ANDON Health Co.,Ltd.

Subject: **FCC Class II Permission Change Request for FCC ID: ZRYBG5S**

This is to request a Class II Permission Change Request for FCC ID: ZRYBG5S, originally granted on 09/25/2017.

Figure1(Before the change)

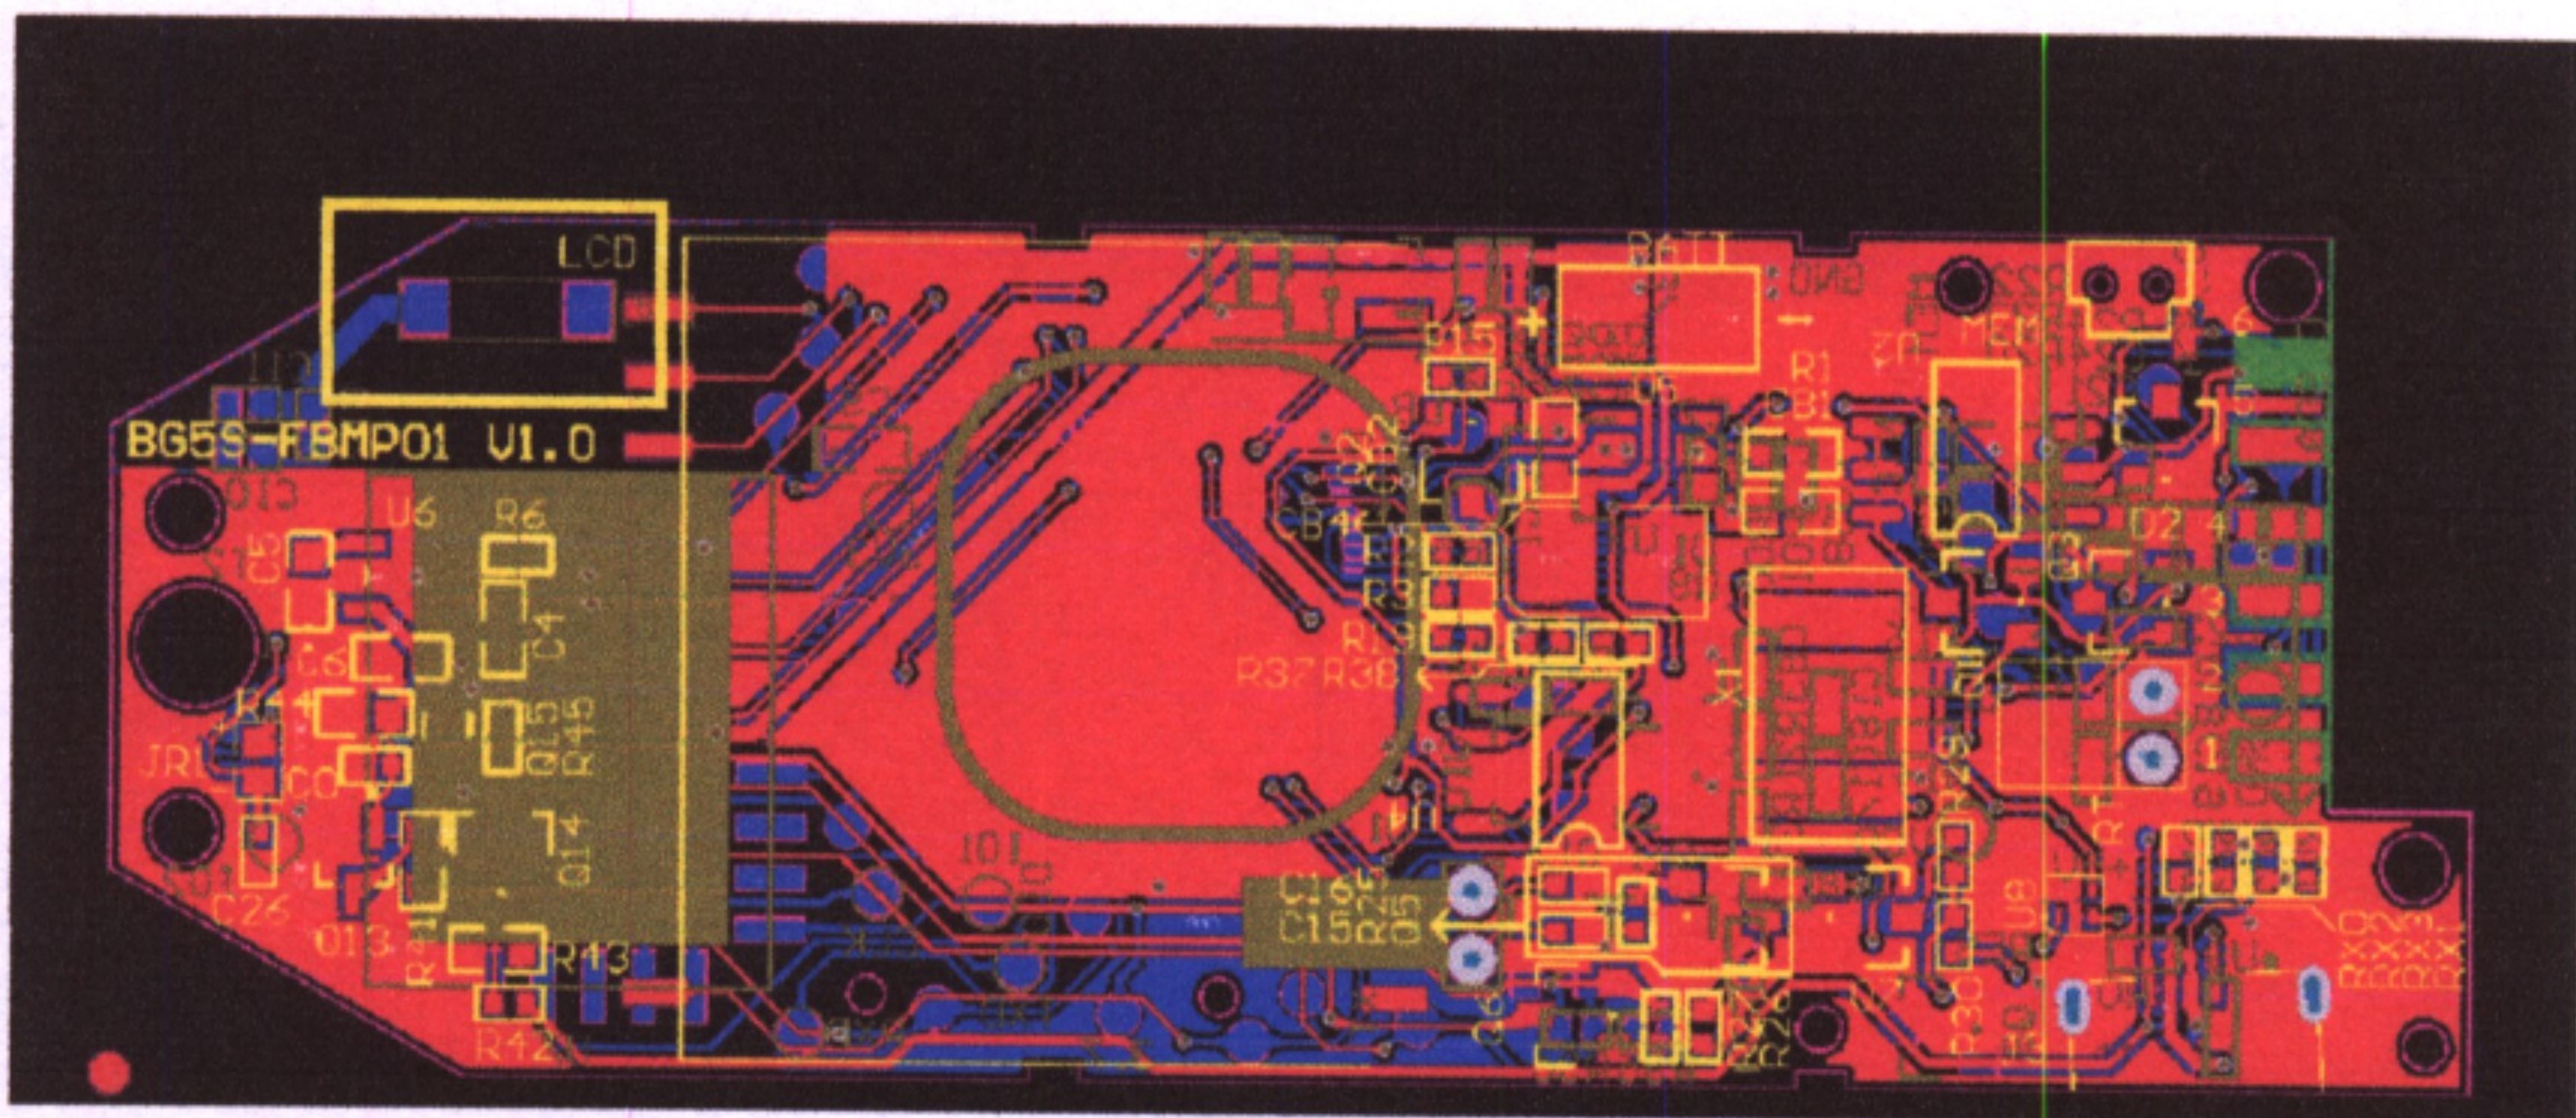
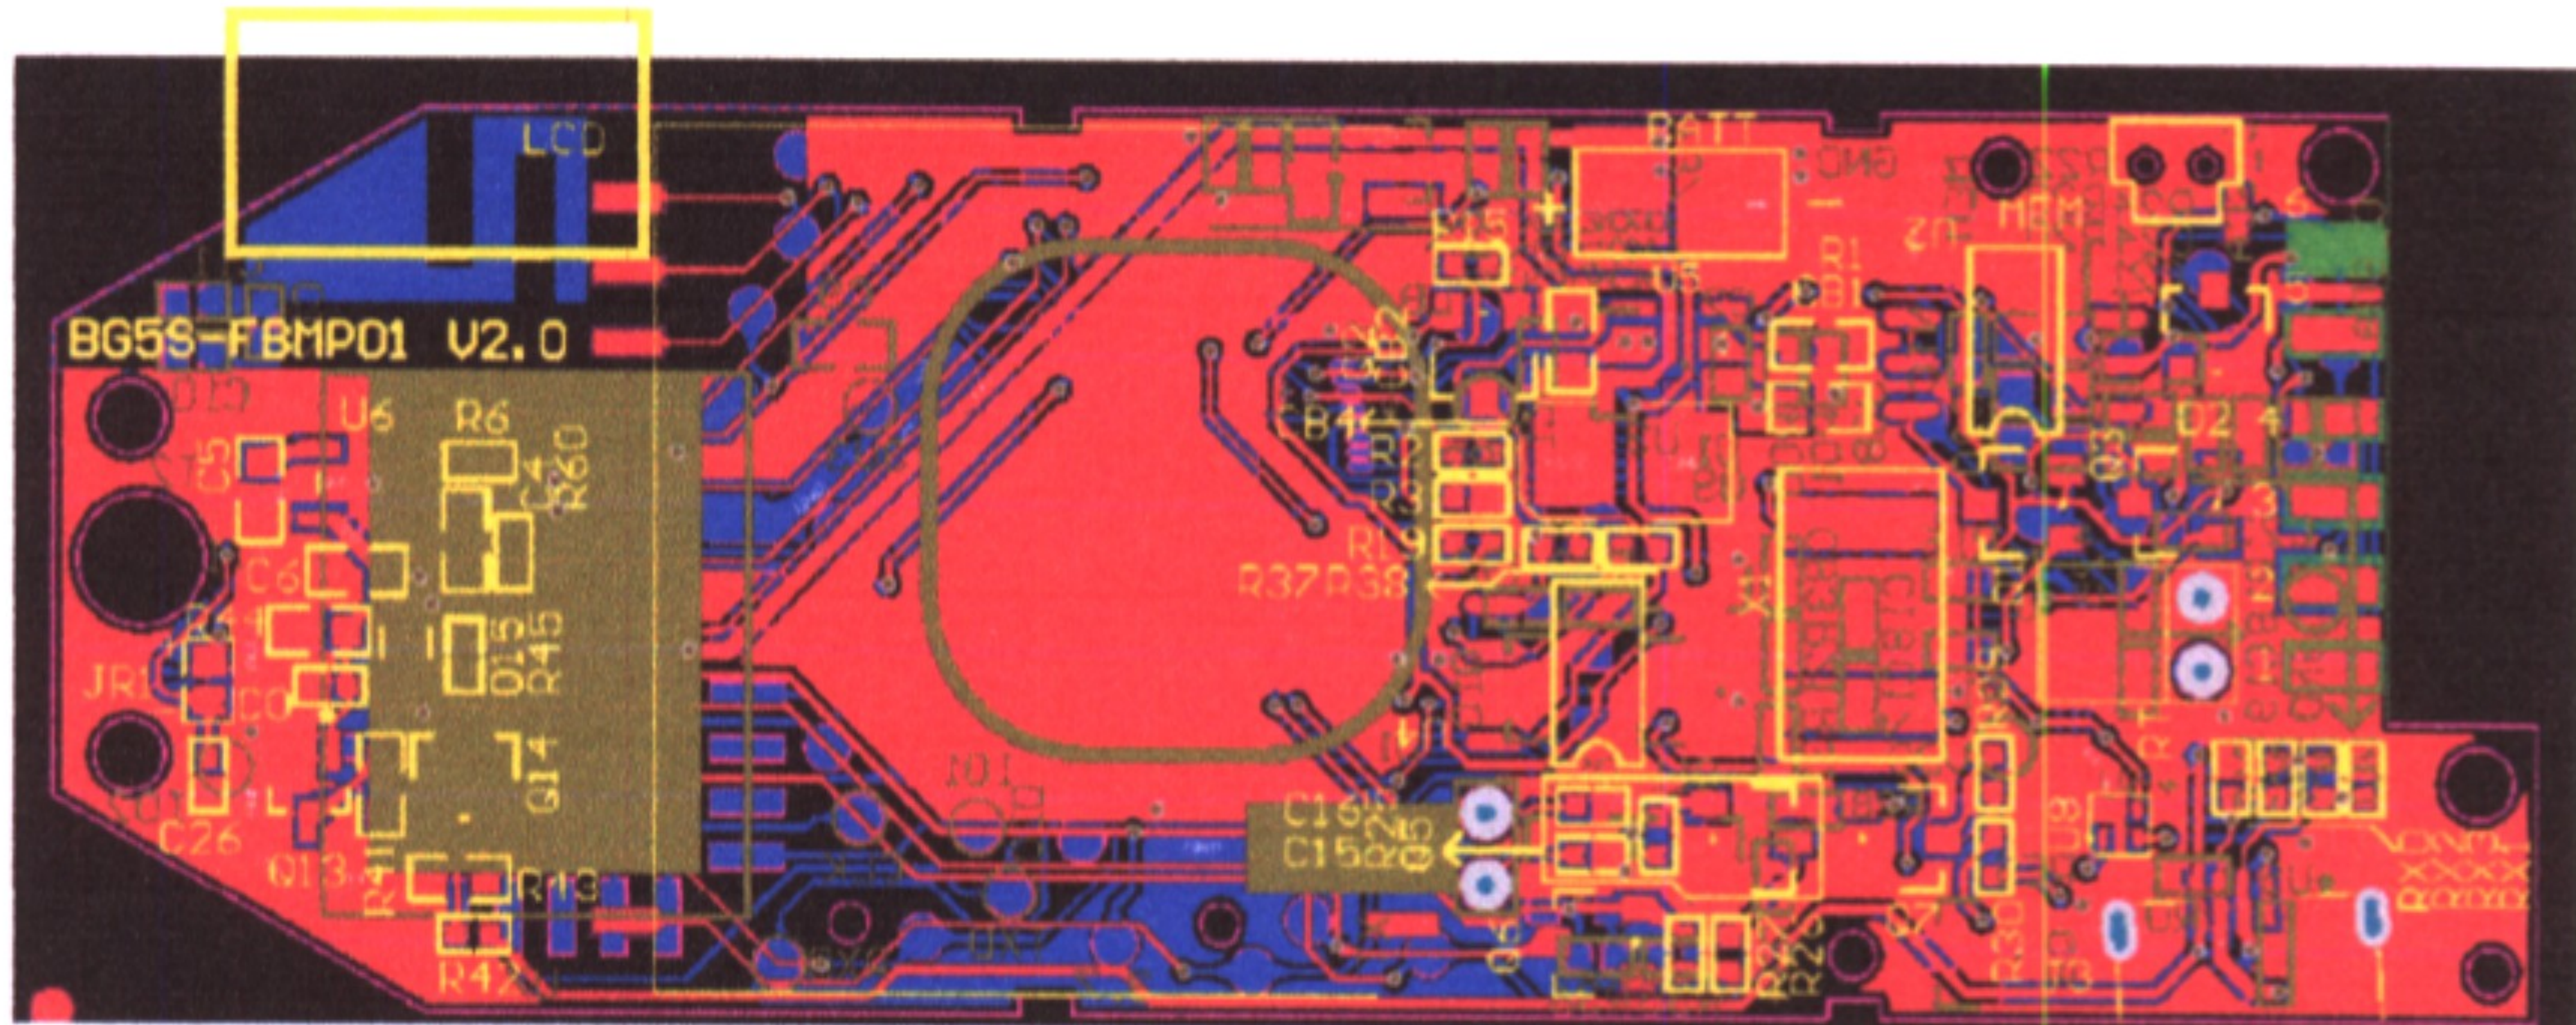
The Major change filed under this application is to change the antenna. The details are shown in the figure below. The chip antenna prototype is in the Figure1. The yellow box in Figure1 is the chip antenna. The PCB antenna prototype is in the Figure2. The yellow box in Figure2 is the PCB antenna. The gain of the chip antenna is 5dBi. The gain of the PCB antenna is 2dBi. By the way, the Figure2 add R60, which can test the related MCU I/O working status.
